Re: APP/20/00399

Town and Country Planning Application for proposed development at 76 Southleigh Road, Havant, Hampshire. P09 2QL

GROUND FLOOR
PROPOSED FLOOR LAYOUT
SCALE 1 : 50

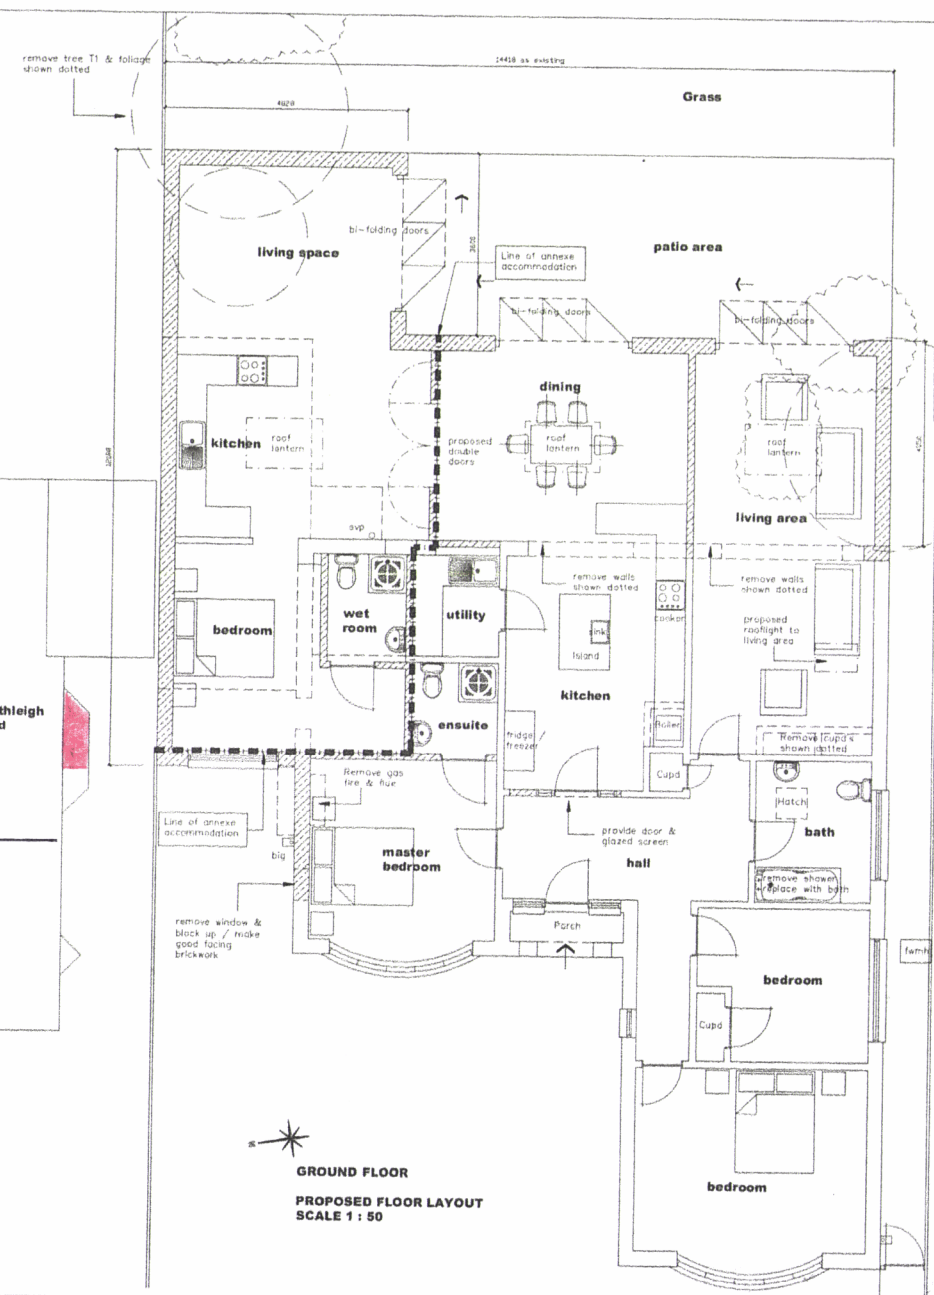
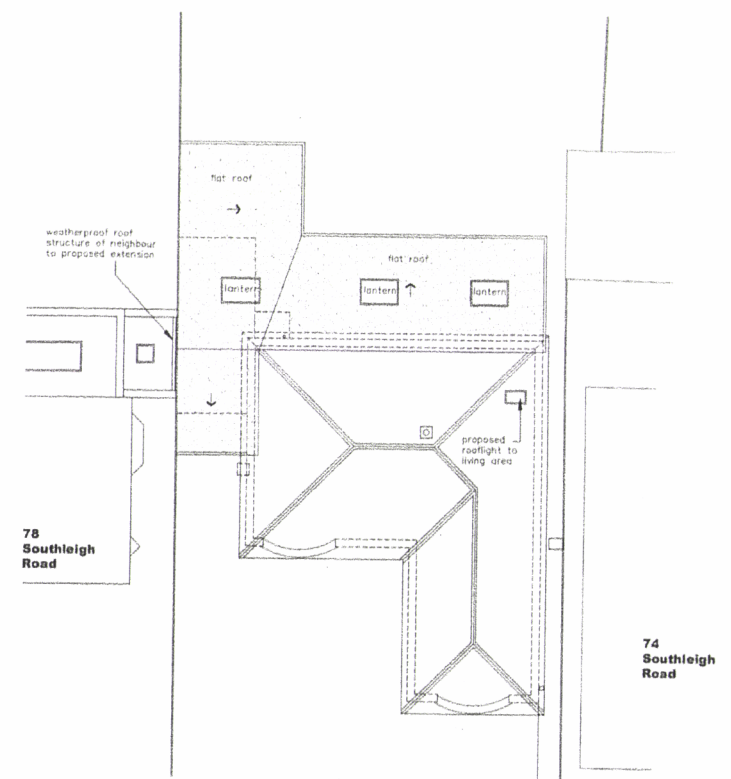
How can building a brick wall which will totally obliterate 2/3rds of my lounge window be deemed as not reducing my amenities. This window has been in existence in its present position and in relationship to the neighbouring property since the houses were constructed in the 1950's. It has, therefore, provided unobstructed access to light in a main living room since that time (approximately 70 years). (See attachment A marked in red)

This is a south facing window and therefore, benefits from light and sunshine into my lounge throughout the day. Obscuring 2/3rds of it would necessitate electric lighting to be used to maintain any way near the same daytime levels of light I have previously been able to enjoy, especially during the winter months. (Attachment A marked in red).

GROUND FLOOR
EXISTING FLOOR LAYOUT
SCALE 1 : 50

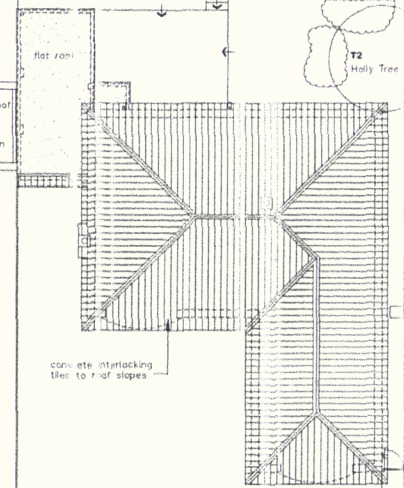
Applying the 45-degree rule (Council Residential Design Guidelines) it can be clearly demonstrated that the proposed extension will dramatically impact on my property. It should be noted that the existing garage structure conforms to this guideline. (Attachment B marked in red). Therefore, I object to this proposal to obstruct my window. Should the plans be amended to restrict the planned building to remain at that existing building line, leaving my window unobstructed and adhering to the 45-degree rule, there would be no cause for concern or objection on this point.

My Lounge which will be severely affected by the loss of daylight through the south facing window.

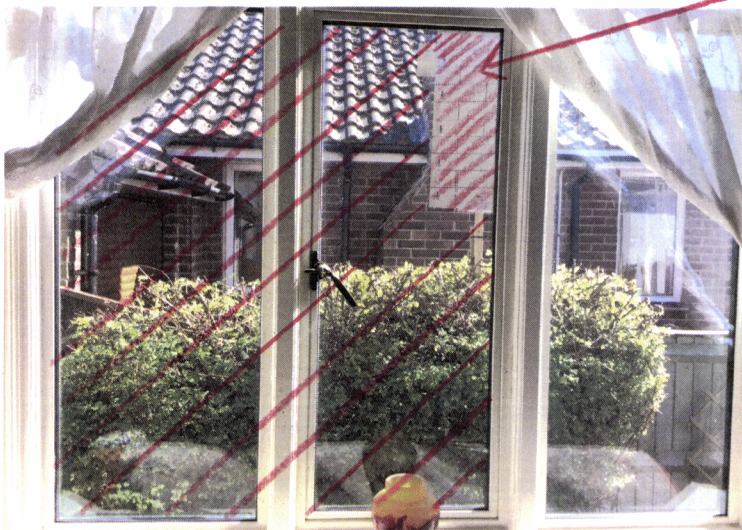
This is the view directly out of my Lounge Window.

Another view out of my lounge window. Note the Garage at 76 Southleigh may seen on the left side of the photo.

BOARD DEMONSTRATES
AMOUNT WINDOW
WILL BE AFFECTED.

In this photo I have placed my sheet of cardboard on the fence line to simulate the end and height of the proposed wall. This completely blocks 2/3 the view and light out of my Lounge window.
